Development Permit Panel

Council Chambers, City Hall 6911 No. 3 Road Wednesday, March 10, 2021 3:30 p.m.

Motion to adopt the min January 27, 2021.	utes of the Development Permit Panel meeting held on				
1.	DEVELOPMENT PERMI (REDMS No. 6614322 v. 4)	T 17-768763				
	APPLICANT:	Landcraft Homes Ltd.				
	PROPERTY LOCATION:	5751 Francis Road				
	Director's Recommendati	ions				
	That a Development Permit be issued which would permit the construction of a triplex at 5751 Francis Road on a site zoned "Arterial Road Three-Unit Dwellings (RTA)".					
2.	New Business

PLAN 12 LIGHTING PLAN

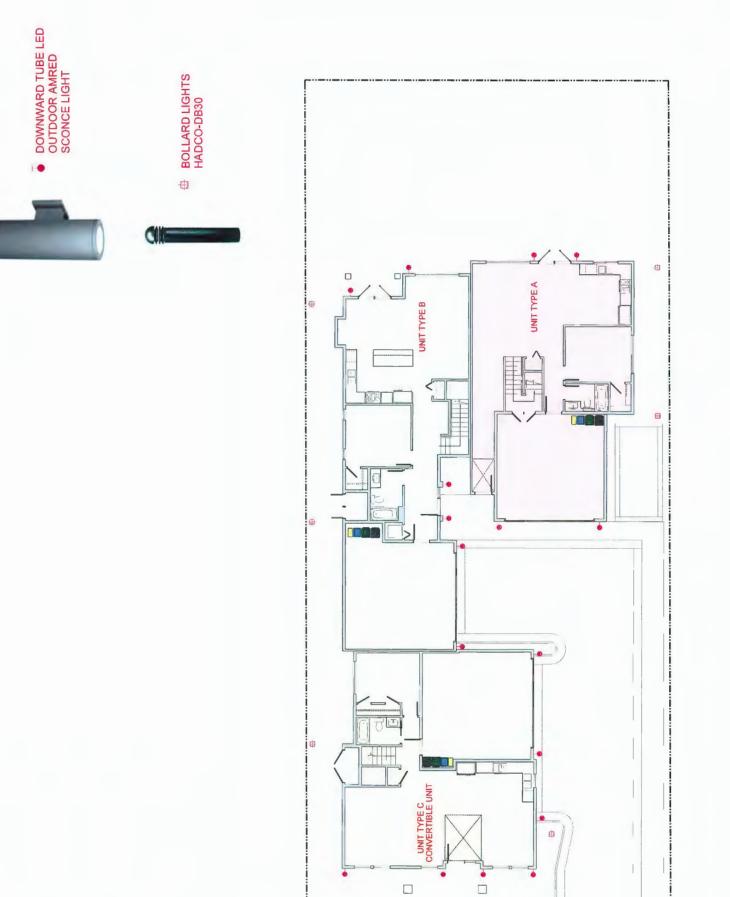
The lighting plan has been updated according. Ref. sheet A-504.

A-401

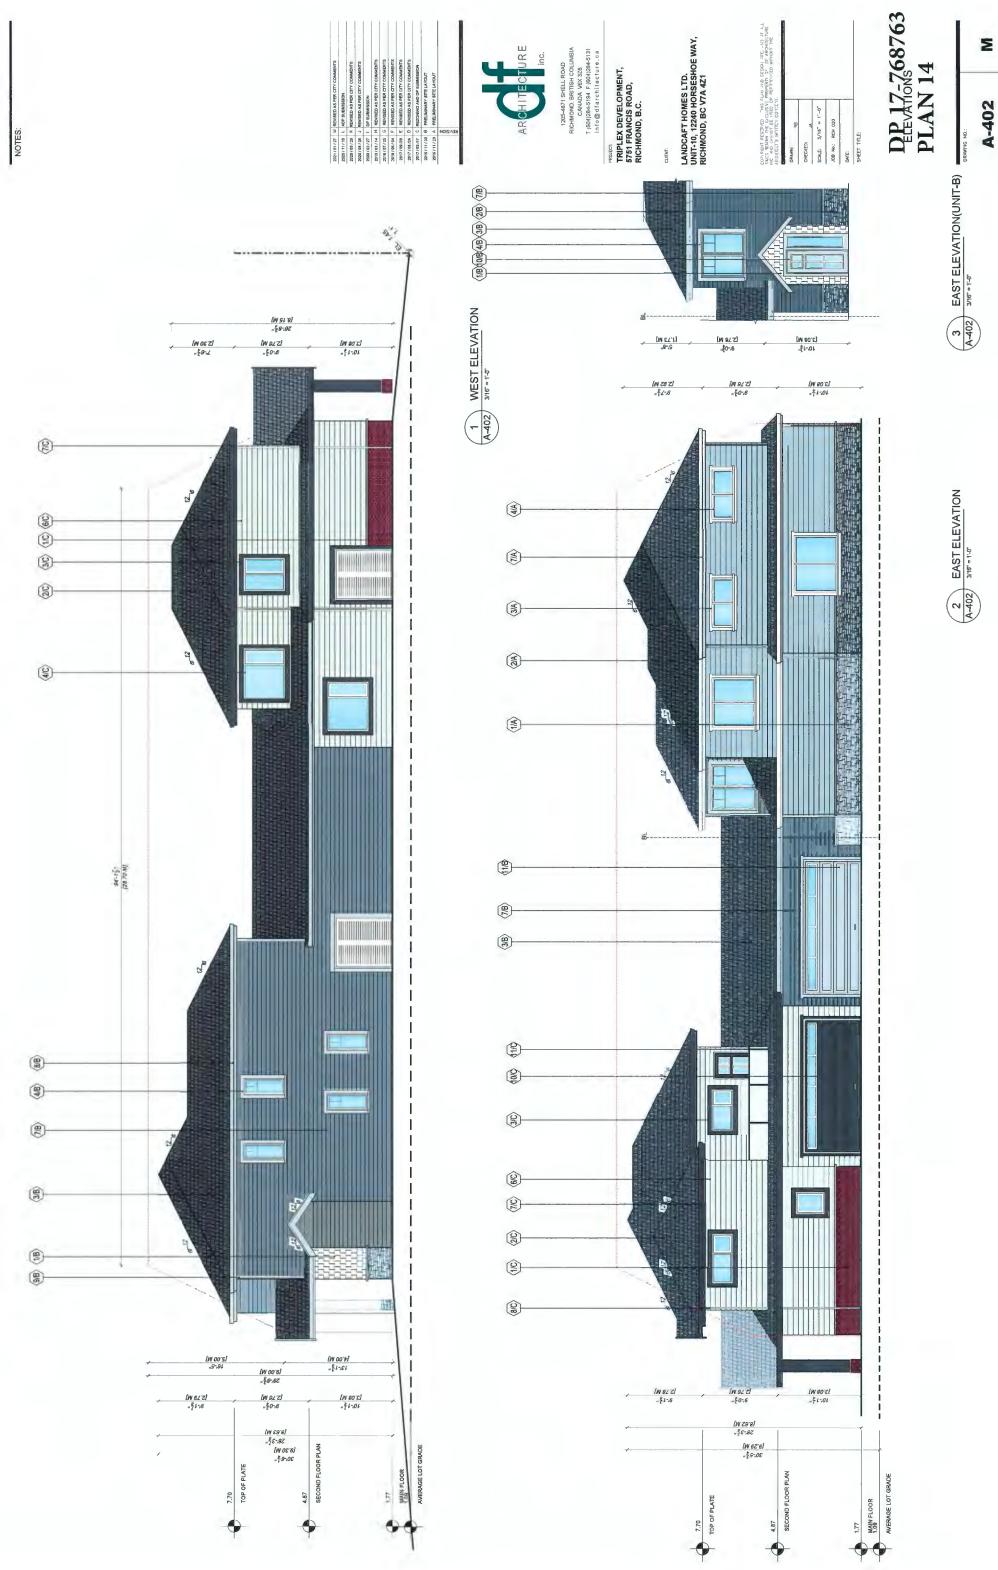
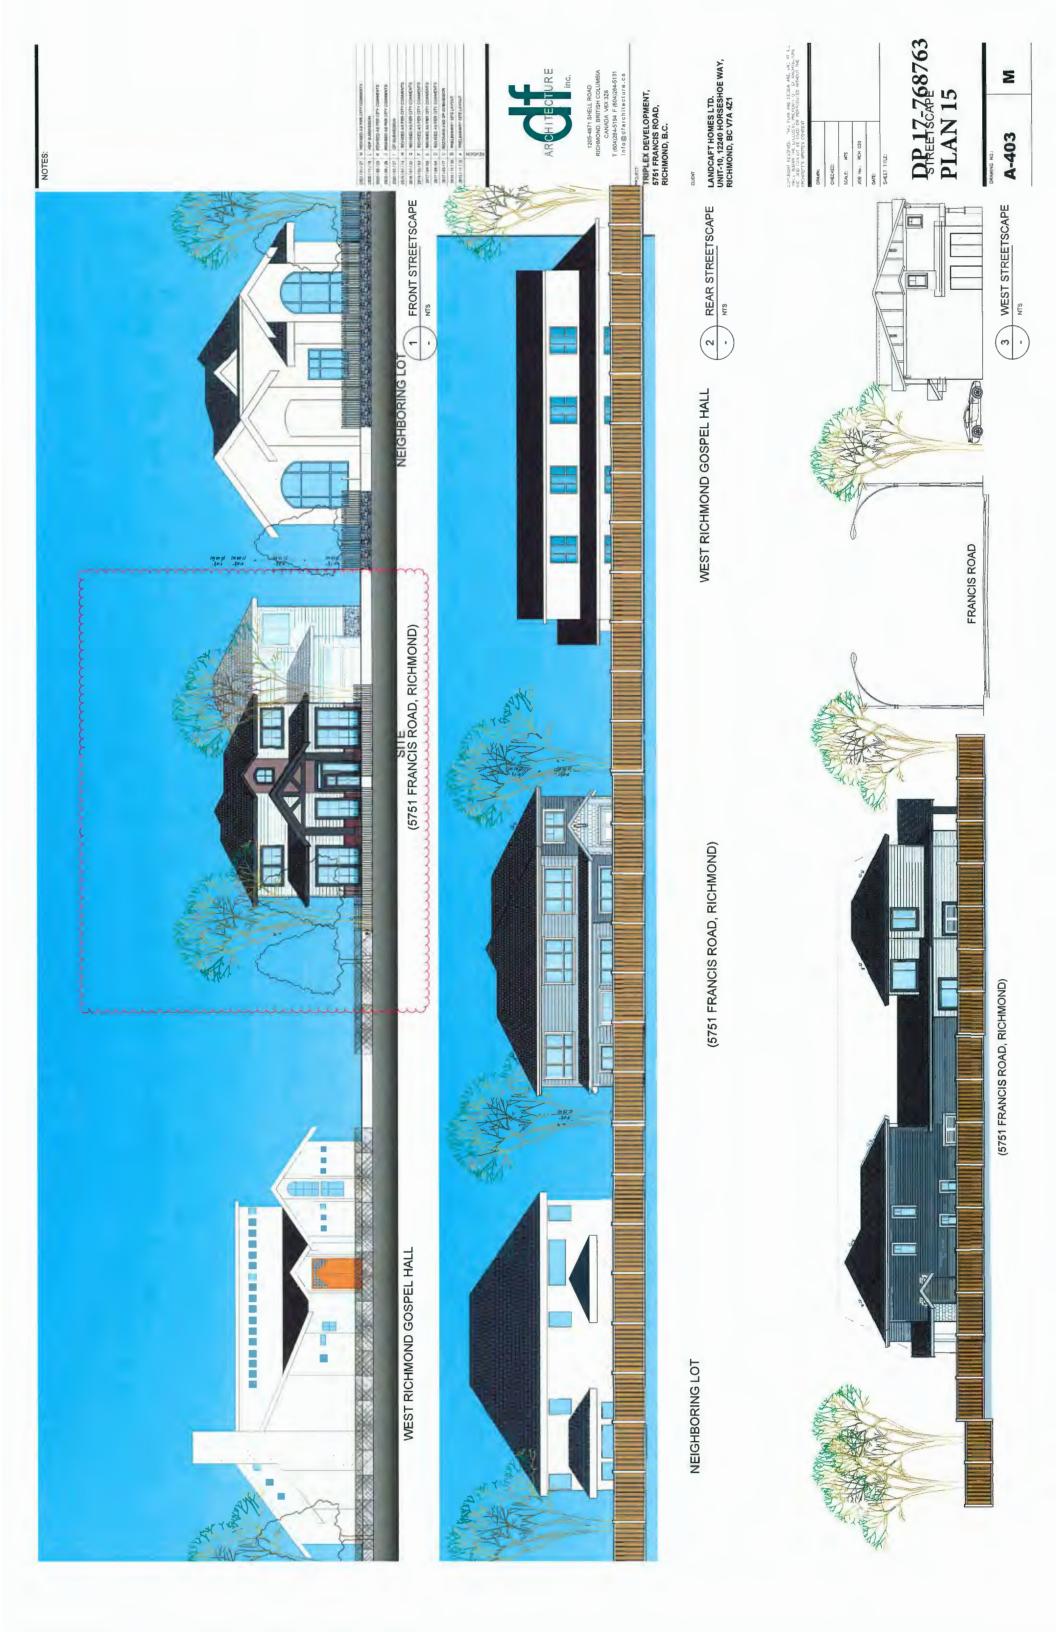
agree with the Panel comment that the materials and elevations of the northeast and northwest units (Unit A and Unit B) make sense but the front elevation of the unit facing the street (Unit C) does not tie in with the other building façades;

The front elevation along Francis Road has been revised to better respond to the neighbourhood context. Ref. Sheet A-401.
